# SPECIFICATION

**MFG: CHANCE RIDES, INC.**  
**NAME: SKY DIVER**  
**TYPE: NON-KIDDIE**

# SKY DIVER

Latch Engaged In Slot In A-Frame

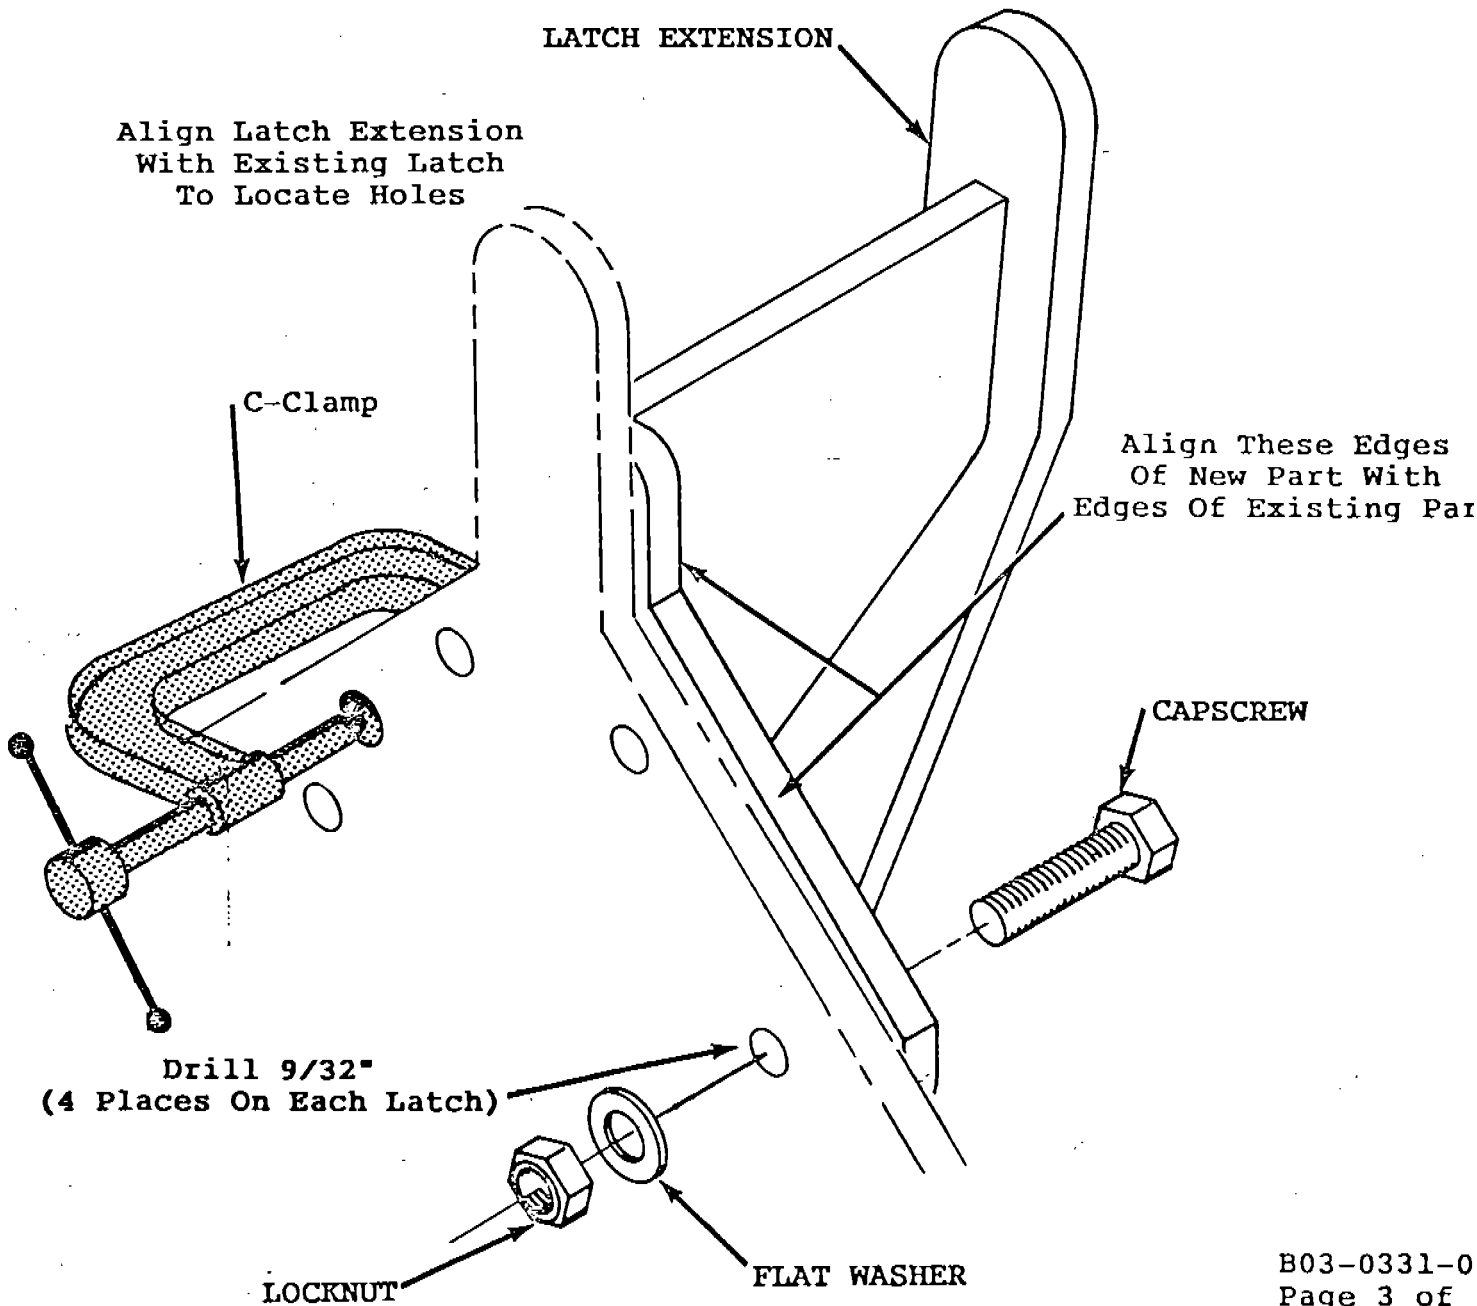
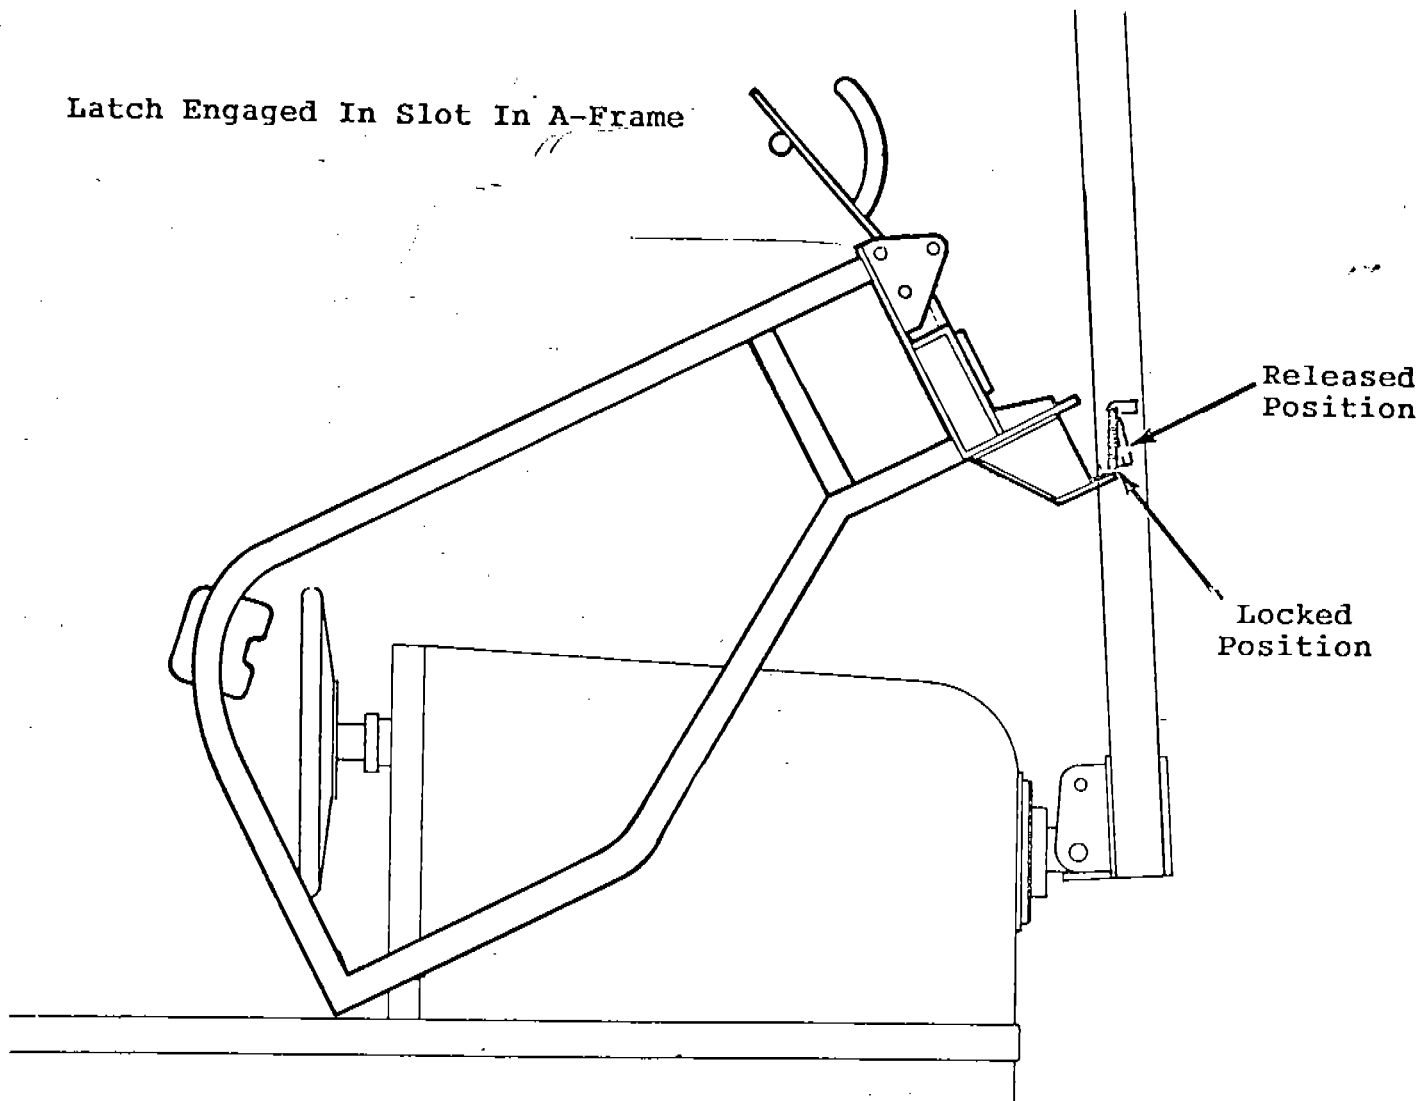
A modification kit has been developed to increase the clearance between the lap bar and the control wheel, reducing the possibility of injuries due to pinched hands and/or fingers.

1. Align the edges of latch extension (Item #1) with the edges of the existing latch as shown in the illustration below.
2. Use a C-clamp to hold the latch extension in place as shown.

3. Rotate the hatch to the open position as shown and check to make sure that:

- The latch securely engages in the A-frame slot for loading and unloading (Locked Position).
- The latch will release properly when the latch release is disengaged (Released Position).

**NOTE:** If necessary, adjust the latch extension position slightly to obtain the correct engagement into the A-frame slot. Also, the tang of the latch extension can be ground shorter to allow the correct release from the latch.

TIE DOWN CABLE  
(CUSTOMER FURNISHED)

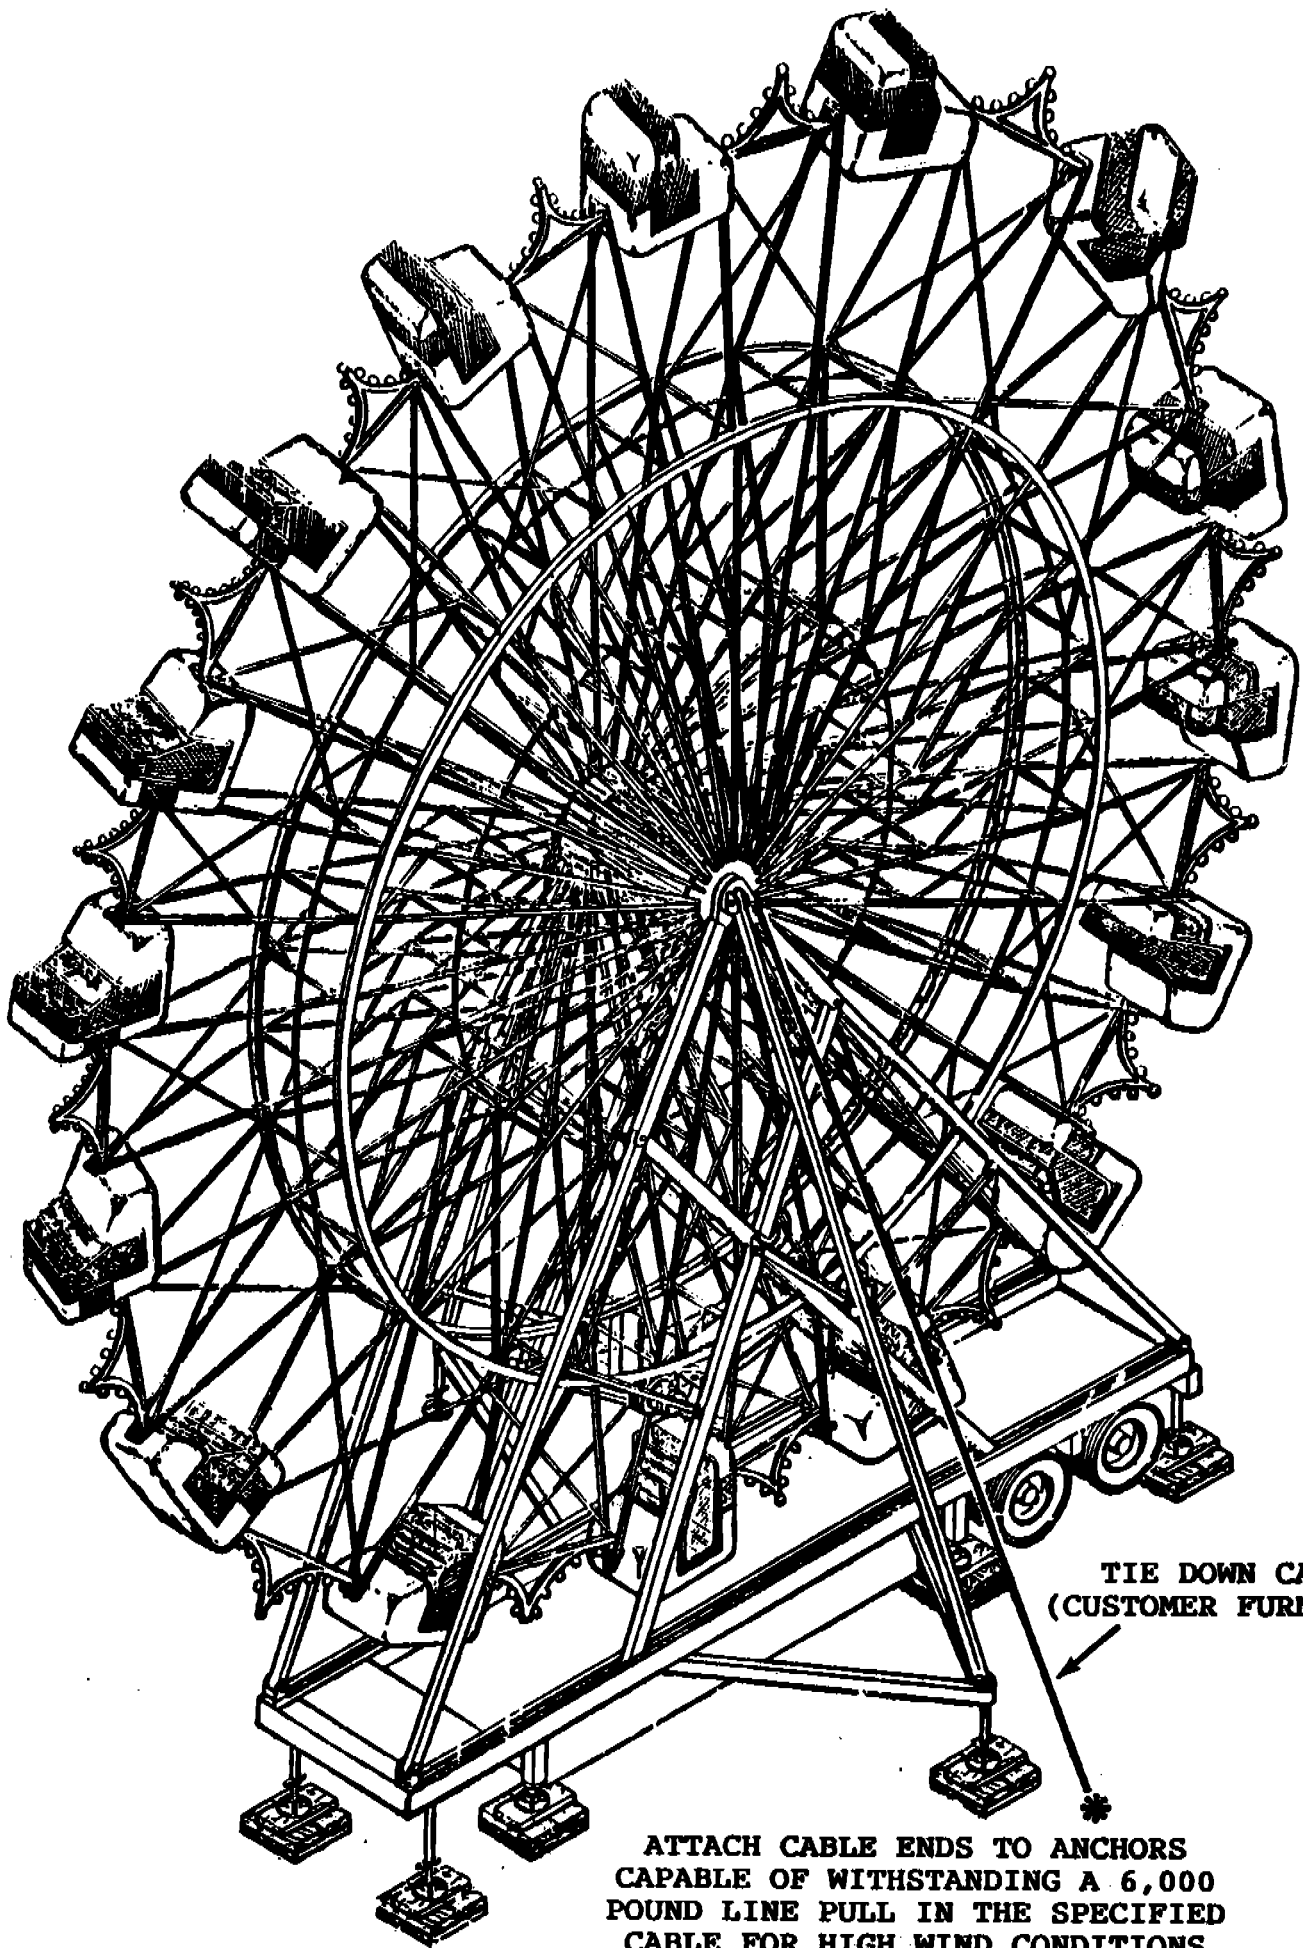
The modification consists of welding links to the ride towers, to be used as anchors for tie-down cables if required by wind conditions. After the modification is performed, always follow the recommended blocking and tie-down procedures.

1. Attach cables to the pear links on the tower legs. Attach the other end of each cable to anchors capable of withstanding a 6,000 pound line pull in the specified cable. (See illustration on next page).
2. Tighten the cables until snug.

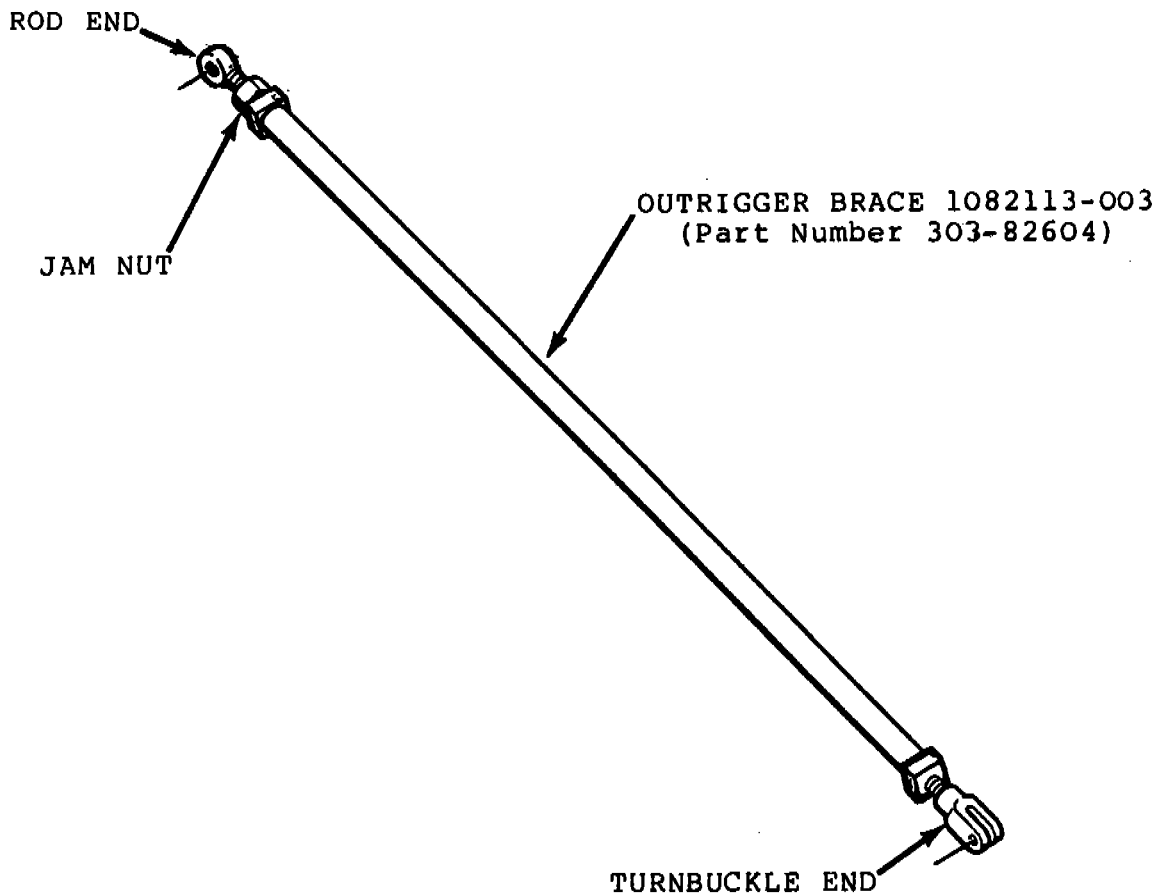
CHANCE MANUFACTURING COMPANY, INC. has developed a rigid brace to replace the existing bar and turnbuckle brace on the new style outrigger supports on SKY DIVERS and ASTRO WHEELS. This rigid brace will further increase the stability of the outriggers.

1. Remove the bar and turnbuckle assembly from one side of the ride.
2. Install the new outrigger brace using the existing hardware.

FIGURE A

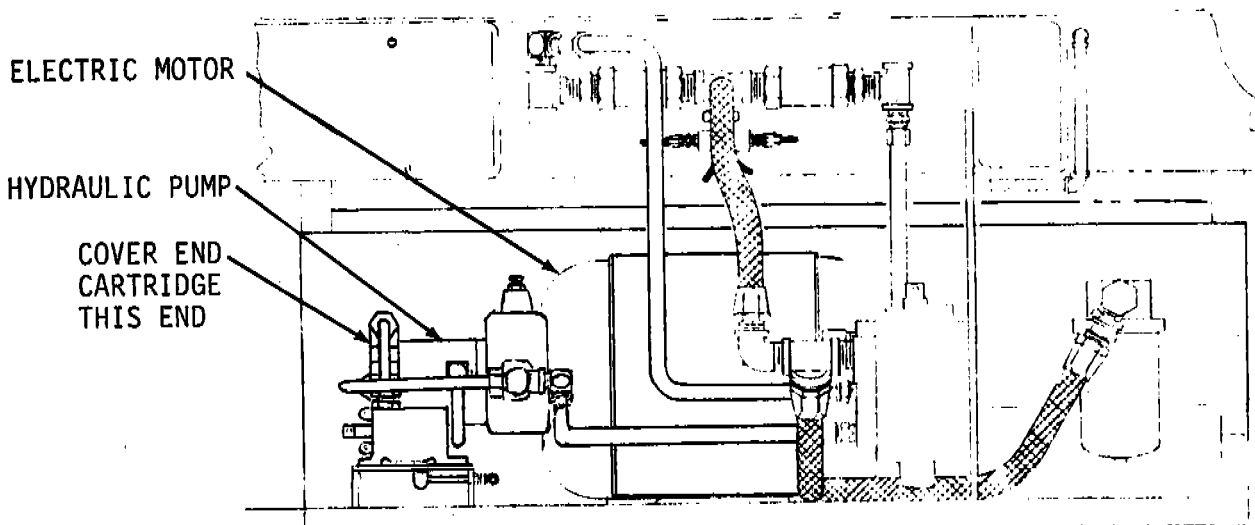
1. Pump Change

Replace the cover end pump cartridge of existing 3520V pump (located on end of electric motor with #923446 cartridge kit, following instructions given in Vickers Service Manual #M-2300-S. Restamp pump to 3520V35A8 (was previously 3520V35A11). (SEE FIGURE A)

FIGURE B

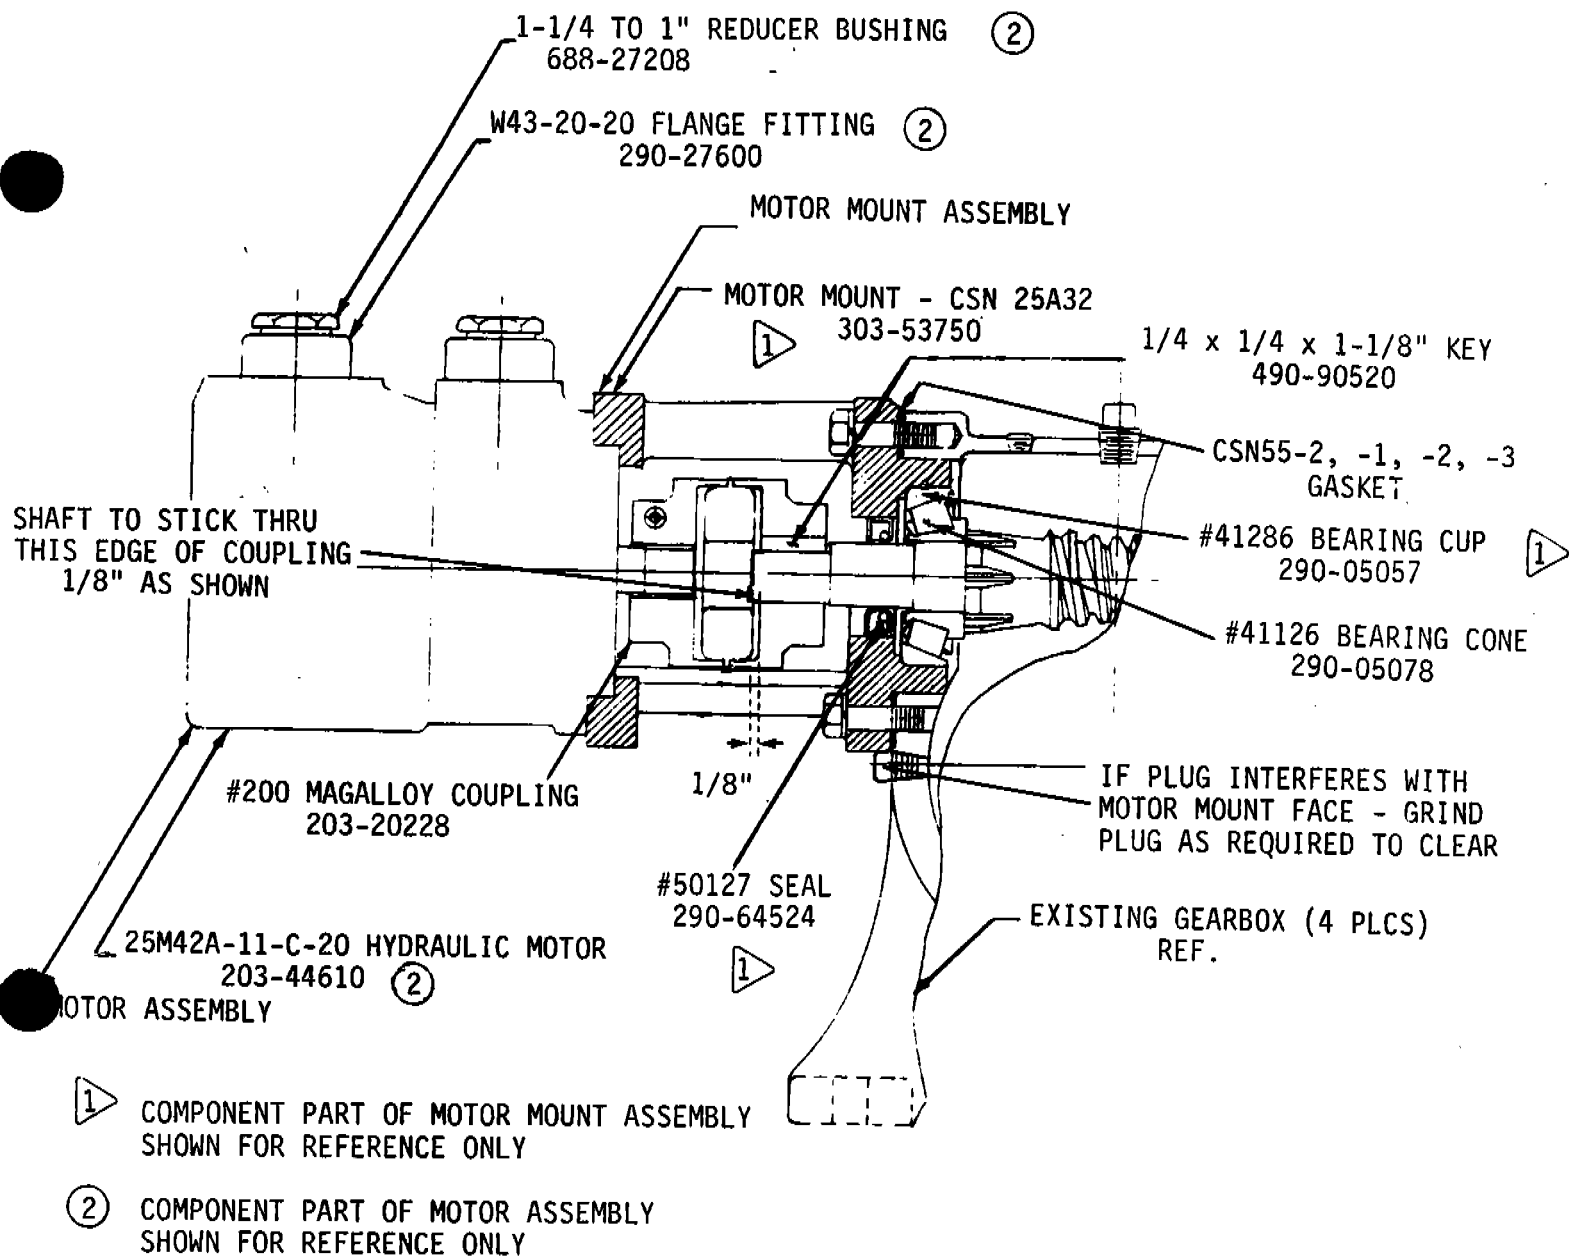
2. Remove existing hydraulic motor, motor mount, couplings, bearing and gaskets from input side of drive gearbox. (SEE FIGURE B)
3. Install new bearing #41126 on input shaft and shim as required between motor mount and gearbox with CSN55-2, -1, -2 and -3 gaskets to adjust input shaft bearings. Use shim thickness of .030 for initial setting. Refer to Cone Drive Assembly Manual for proper adjustment.

NOTE: Index motor mount assembly as required to locate hydraulic motor ports in proper alignment when hydraulic motor is installed.

FIGURE B

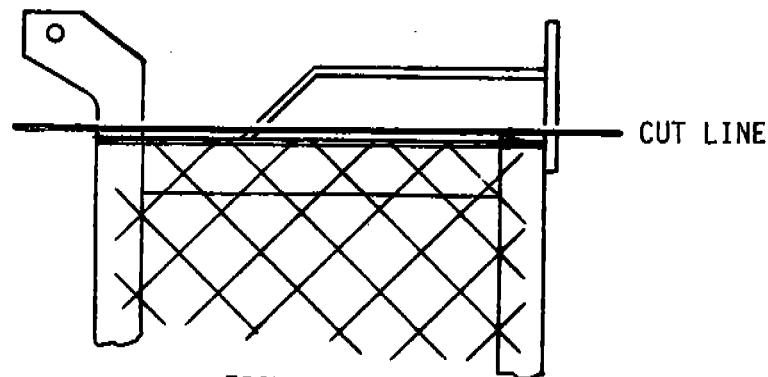
1. Weld on type (65-1202 THRU 74-1259) - Cut old latch off of hatch as shown in Figure B and grind remainder of latch level with top of screening. Position new latch assembly as shown in Figure A and drill four (4)  $9/32$ " mounting holes through hatch frame (Arrow A). Attach latch to hatch frame using four (4) Grade 5,  $1/4$ -20x1- $3/4$  bolts and  $1/4$ -20 lock nuts. Heads of bolts must be on the inside of the car.

2. Bolt on type (65-1201, 75-1260 THRU 78-1272) - Remove old latch. Use four (4) Grade 5,  $1/4$ -20x1- $3/4$  bolts and two (2) Grade 5,  $1/4$ -20x1" bolts and six  $1/4$ -20 locknuts to secure new latch assembly to hatch. Heads of bolts must be inside car.
